NOTICE OF NON-PERFORMANCE

On January 28, 2026, Energy Safety conducted an inspection of Southern California Edison Company's WMP initiatives in the vicinity of the city of Canyon Country, California. The inspection report is enclosed herewith. Energy Safety found the following deficiencies:

INSPECTION REPORT

Deficiency 1

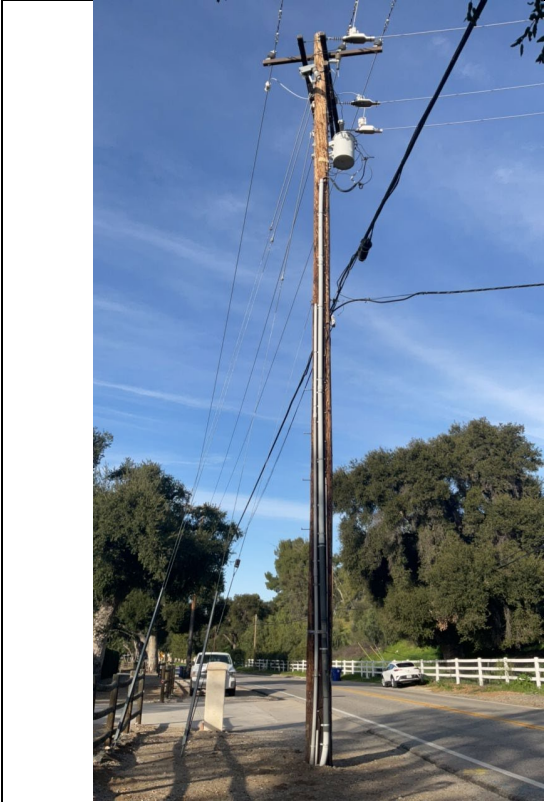
On Pole ID 4925994E, Grid Hardening ID 414606467-4925994E at 27505 Sand Canyon Rd, Canyon Country, CA, 91387, USA, 34.4078317001898, -118.420343456959, the inspector observed acorns were present within the avian protection guard. The inspector's observation is documented in Deficiency 1 photographs, which are attachments to this report. Photo numbers IA1Img1, IA1Img2, IA1Img3 and IA1Img4 depict that the avian cover was filled with acorns.

1. Per information submitted by SCE to Energy Safety, an inspector observed acorns in multiple avian protection guards at the location in April 2025.
2. Southern California Edison Company's 2025 Quarter 3 QDR identified this location as having completed work under 2025 WMP initiative number 8.1.3.1 Distribution Detailed Inspections and Remediations, related to the condition of multiple avian protection guards being filled with acorns.
3. One of the avian protection covers was filled with acorns at the time of Energy Safety's inspection.

Deficiency 1. Energy Safety observed that in implementing 2025 WMP initiative 8.1.3.1 - Distribution High Fire Risk-Informed (HFRI) Inspections and Remediations (IN-1.1), SCE failed to complete the remediation of multiple avian guards with obstructions on Pole ID 4925994E, Grid Hardening ID 414606467-4925994E at coordinates 34.4078317001898, -118.420343456959. Energy Safety considers this non-performance to be in the Minor risk category. SCE must complete a corrective action for this deficiency by 12 months from the date of this notice.¹
